1. Thank you for the opportunity to review the proposal for a vehicle dismantling facility, associated buildings and curtilage storage area, earthworks, stormwater management, and planting at 395 Fitzgerald Road, Drury.
2. My full name is Gabrielle Katarina Howdle. I completed my Bachelor of Landscape Architecture (Honours) from Unitec, Auckland in 2016. I have been employed by Auckland Council as a landscape architect since 2017 and I currently hold the position of Principal Landscape Architect within the Tāmaki Makaurau Design Ope. My qualifications and experience are set out in Appendix A - Experience and Qualifications of this memo.
3. I confirm that the issues addressed in this memo are within my area of expertise, except where I state that I rely upon the evidence of others.

15. The proposal is for a vehicle dismantling facility, associated buildings and curtilage storage area, earthworks, stormwater management, and planting on the 2.7679ha site at 395 Fitzgerald Road (See figure 1 below).

Gabrielle Howdle
Principal Landscape Architect
Tāmaki Makaurau Design Ope
Auckland Council

Figure 2: Western boundary sections.

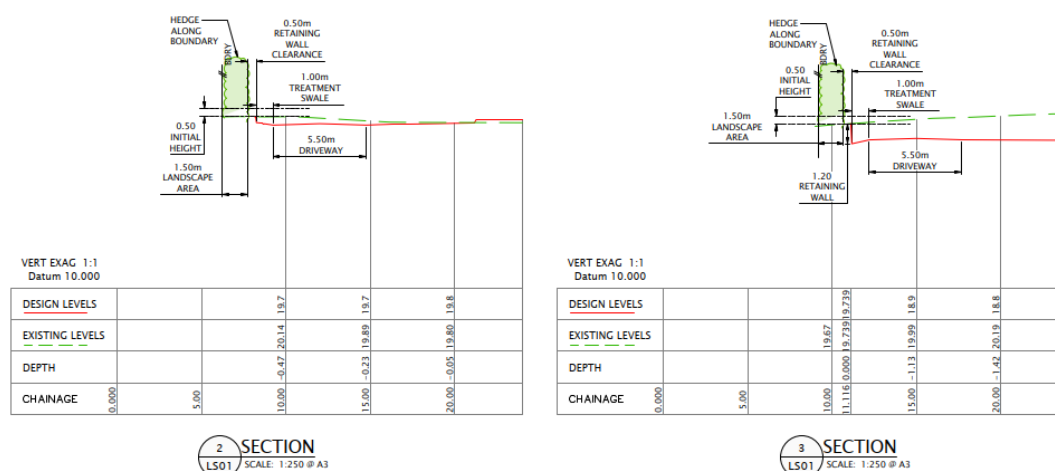
29. Screen planting is proposed along the western boundary measuring a maximum 1.5m depth (in front of retaining walls along the boundary). This comprises *Pittosporum crassifolium* (karo) planted at 1L at 1.4m spacing. (See figure 2 (sections 2 & 3) below).

38. Recognising the anthropogenic modifications to the site, and proposed riparian planting which will improve the values of the tributary within the site, overall, it is considered that the proposal will result in low-moderate adverse physical effects on the landform, but once planting establishes, low positive ecological landscape effects from the planting.

Figure 3 & 4: Eastern boundary planting - Section 8 shows more northern end, and Section 6 shows the southern end.

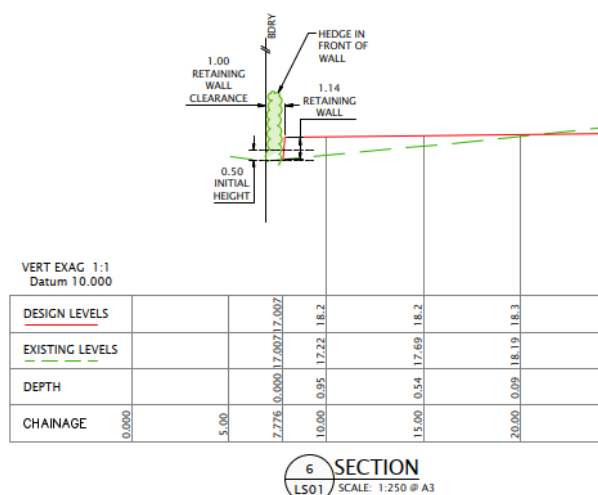
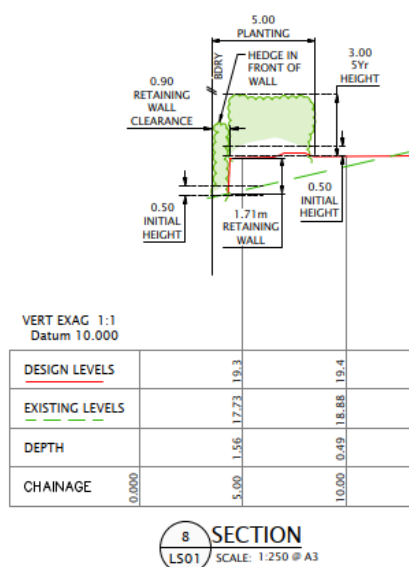
44. While planting (proposed at 1L-2.5L) are proposed along most of the boundaries, this is contained to 1.5m wide strips along the east and west boundaries and up to 5m within the front road boundary and therefore in my opinion is not of a scale comparable with the extent and potential scale of storage of vehicles that could be present on site.

80. It is also noted that the applicant has said in order to maintain the planting proposed along the eastern boundary with this neighbour, that they will need to access the planting from the within the property at 411 Fitzgerald Road. Therefore, the mitigation provided by the planting to integrate the retaining walls and soften the view of storage areas (including as seen from

Figure 5 & 6: Road frontage planted bund. Section 1 shows the western end of the road frontage and Section 7 shows the eastern end of the road boundary.

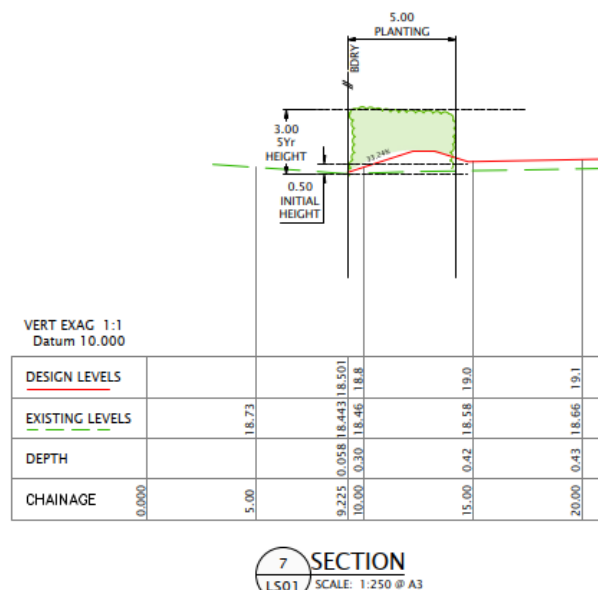
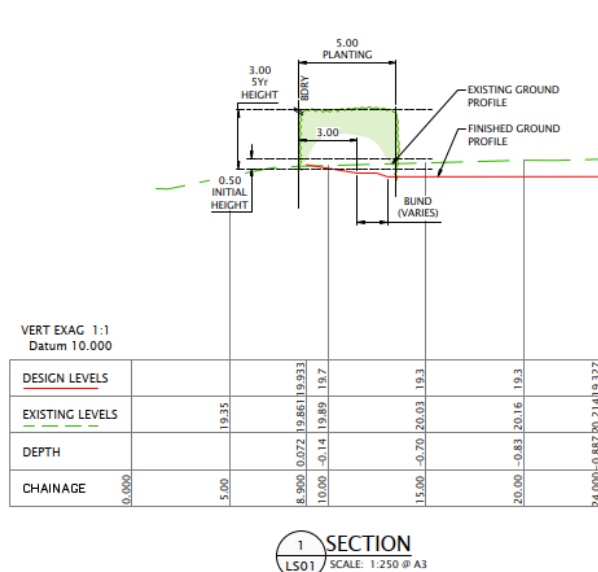
30. Bund planting along the road boundary and the northern to middle portion of the eastern boundary is proposed. This comprises a mix of shrub and small tree species planted at 1L at 1.4m spacings. For the eastern boundary this will comprise planting within a 0.9m gap in front of the retaining wall (up to 2.5m high) and where spacing provides planting at the top of the wall (See figure 3 (section 8) and 4 (section 6) below). A mix (unknown set out) of planting is proposed along the front boundary (See figure 5 & 6 (section 1 & 7) below).
